From: [Kirk Chambers](#)
To: [Lockett, Jay](#)
Subject: Fwd: Planning Commission 2221 BRADFORD DR 40218
Date: Monday, July 17, 2023 12:26:02 PM
Attachments: [Screen Shot 2023-07-15 at 5:20:14 PM.png](#)
[Screen Shot 2023-07-15 at 5:21:02 PM.png](#)
[Screen Shot 2023-07-15 at 7:05:18 PM.png](#)

2221 Bradford Drive

I believe a change from R5 all the way to R6 is too big of a jump for this property. A move to R5A would be more inline with Plan2040.

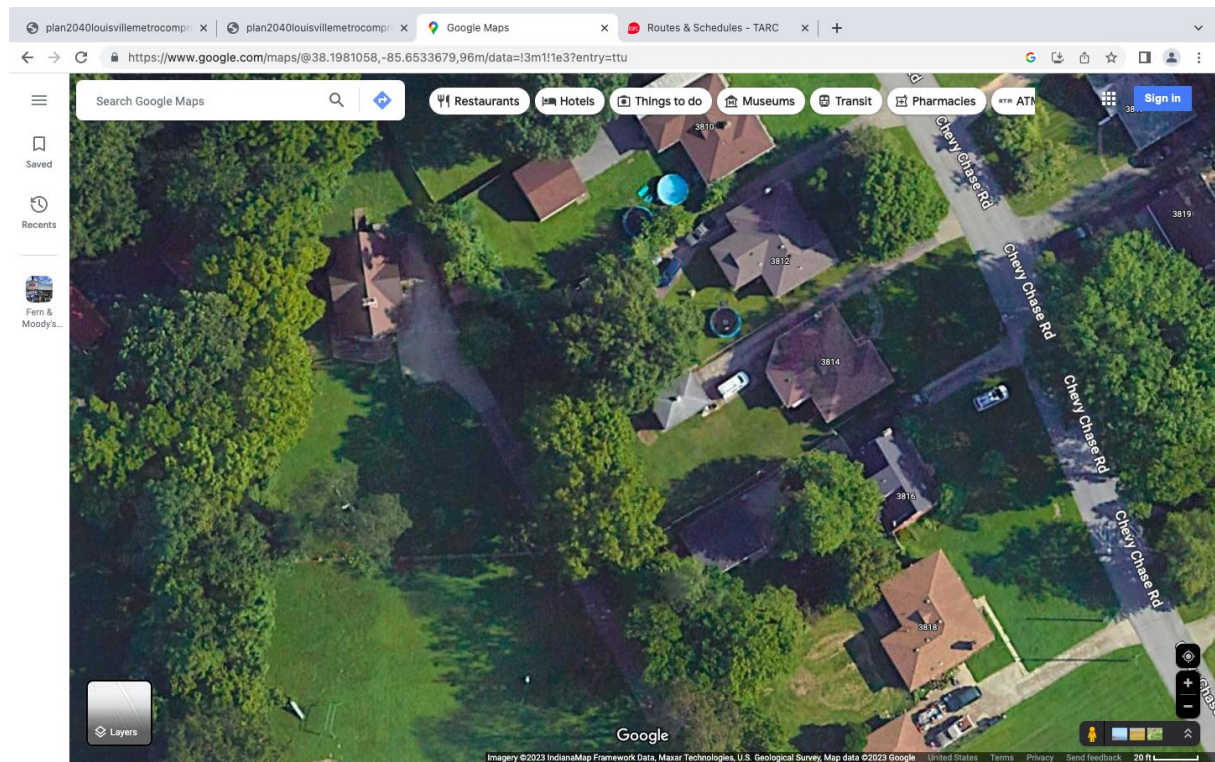
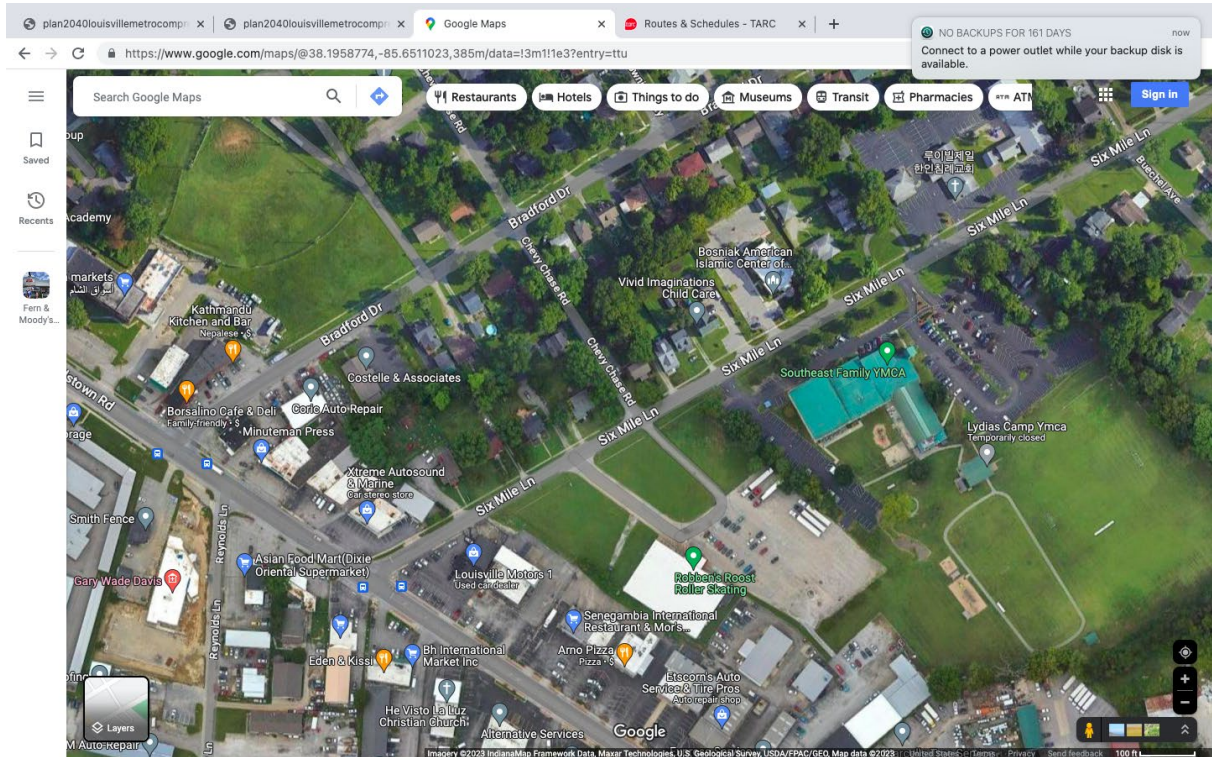
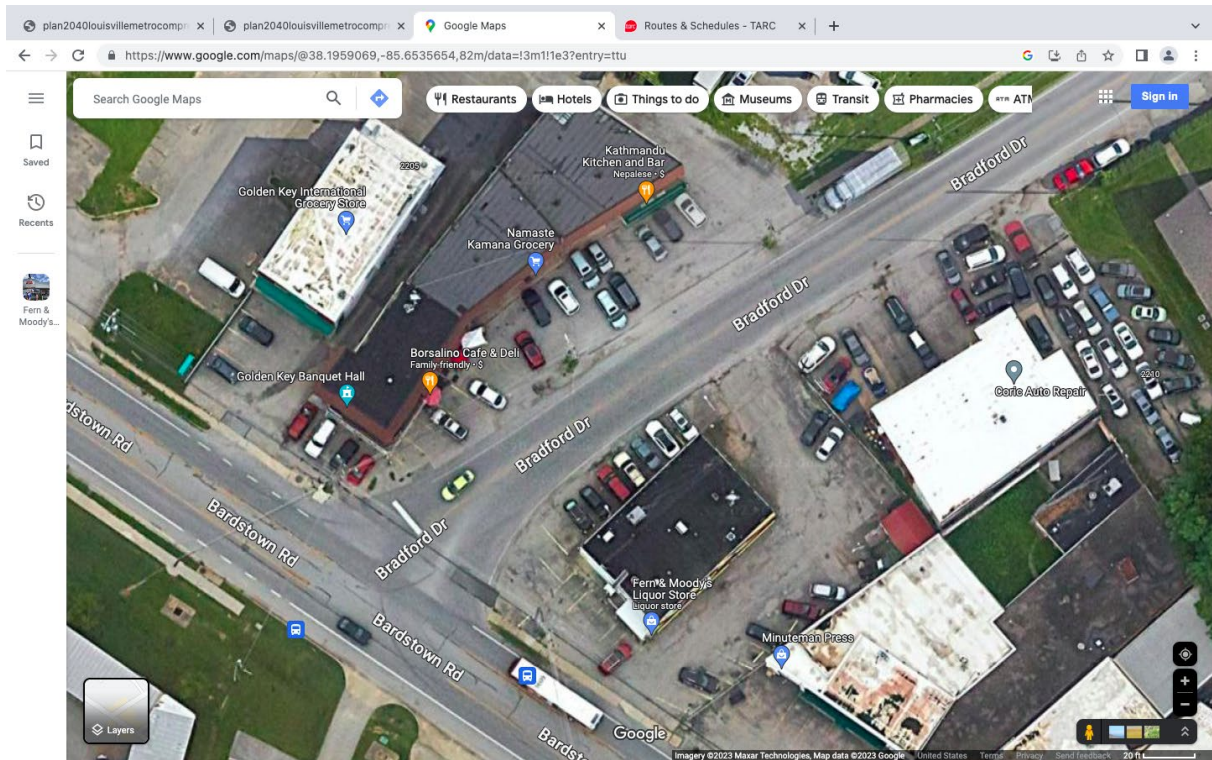
1. 20' setback from property line is inconsistent with neighboring size of yards. Houses are on 100' setback from property line.
2. back door to buildings with no property features to utilize. No natural barrier to expand living space to fence

4. Open space design places buildings up against residential side and away from commercial side.
5. flow of walkers from property to local YMCA will add additional walkers to streets that lack side walks

The proposed design takes the R6 requirements to the limit. 5 of the 6 building contain 16 units. If the 6th building contained the same number of units, it would be over the R6 limit, thus it was reduced to 14 units. The details of the property are pushed to the very limit at the point they interact with the existing housing. This density does not follow the Plan2040
